# Microcomputer Technical Information

<p>QB-78K0LX2 In-Circuit Emulator for 78K0/LE2, 78K0/LF2, 78K0/LG2</p> <p>Usage Restrictions</p>		Document No.	ZBG-CD-06-0051	1/2
		Date issued	August 2, 2006	
		Issued by	Development Tool Group Multipurpose Microcomputer Systems Division 4th Systems Operations Unit NEC Electronics Corporation	
Related documents	QB-78K0LX2 User's Manual: U17468EJ3V0UM00	Notification classification	√	Usage restriction
				Upgrade
				Document modification
				Other notification

## QB-78K0LX2 In-Circuit Emulator for 78K0/LE2, 78K0/LF2, 78K0/LG2 Usage Restrictions

### No. 2 Support of specification changes for option byte

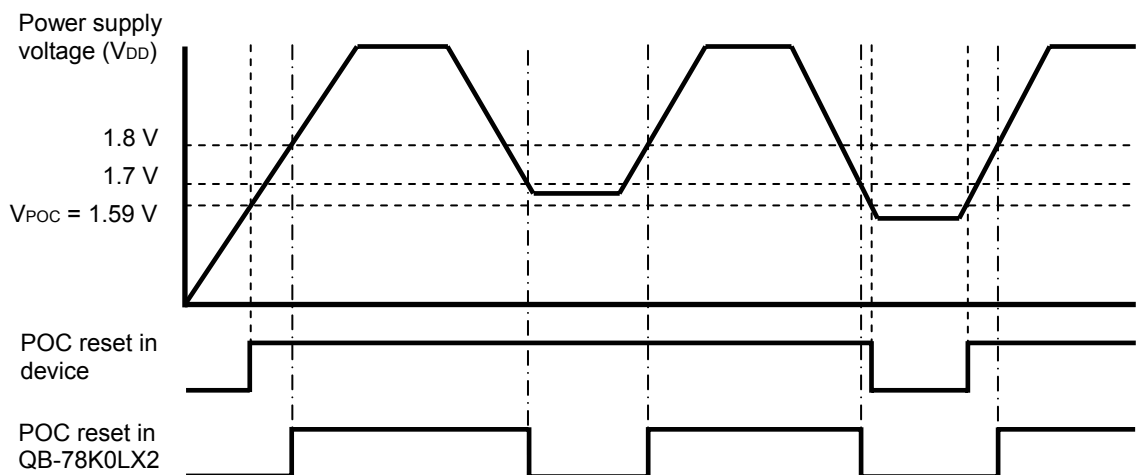
The POC mode (POCMODE) of the option byte is supported in control code B or later.

(2) In 2.7 V/1.59 V POC mode (option byte: POCMODE = 1)

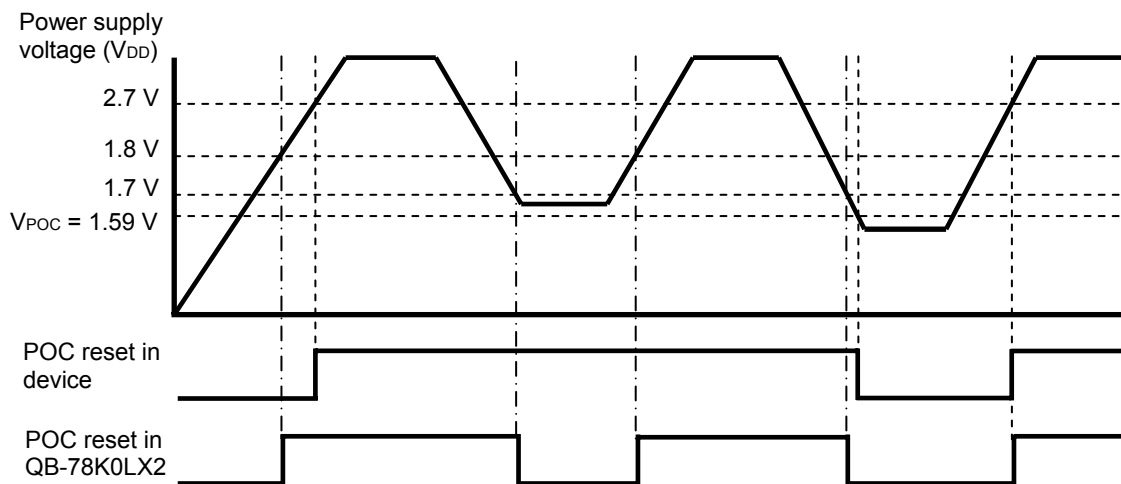
The POC detection voltage differs between the QB-78K0LX2 and the device.

- Device: An internal reset signal is generated at power application, and the reset state is released when the power supply voltage ( $V_{DD}$ ) exceeds  $V_{POC}$  (power detection voltage at power application;  $V_{POC} = 2.7 \text{ V} \pm 0.2 \text{ V}$ ).  
The power supply voltage ( $V_{DD}$ ) and detection voltage ( $V_{POC} = 1.59 \text{ V} \pm 0.15 \text{ V}$ ) are compared, an internal reset signal is generated when  $V_{DD}$  drops lower than  $V_{POC}$  ( $V_{DD} < V_{POC}$ ), and the reset state is released when  $V_{DD}$  becomes 2.7 V or higher ( $V_{DD} \geq 2.7 \text{ V}$ ).

- QB-78K0LX2: An internal reset signal is generated at power application, and the reset state is released when the power supply voltage ( $V_{DD}$ ) exceeds 1.80 V.  
An internal reset signal is generated when the detection voltage ( $V_{POC} = 1.59 \text{ V} \pm 0.15 \text{ V}$ )  $< V_{DD} < 1.70 \text{ V}$ , and the reset state is released when  $V_{DD}$  becomes 1.80 V or higher ( $V_{DD} \geq 1.80 \text{ V}$ ).  
If the power supply voltage ( $V_{DD}$ ) drops to a level of the detection voltage ( $V_{POC} = 1.59 \text{ V} \pm 0.15 \text{ V}$ ), the reset state is released the next time the power supply voltage ( $V_{DD}$ ) exceeds  $V_{POC}$  (power detection voltage at power application;  $V_{POC} = 2.7 \text{ V} \pm 0.2 \text{ V}$ ).

There is no workaround. Regard this item as a permanent restriction.
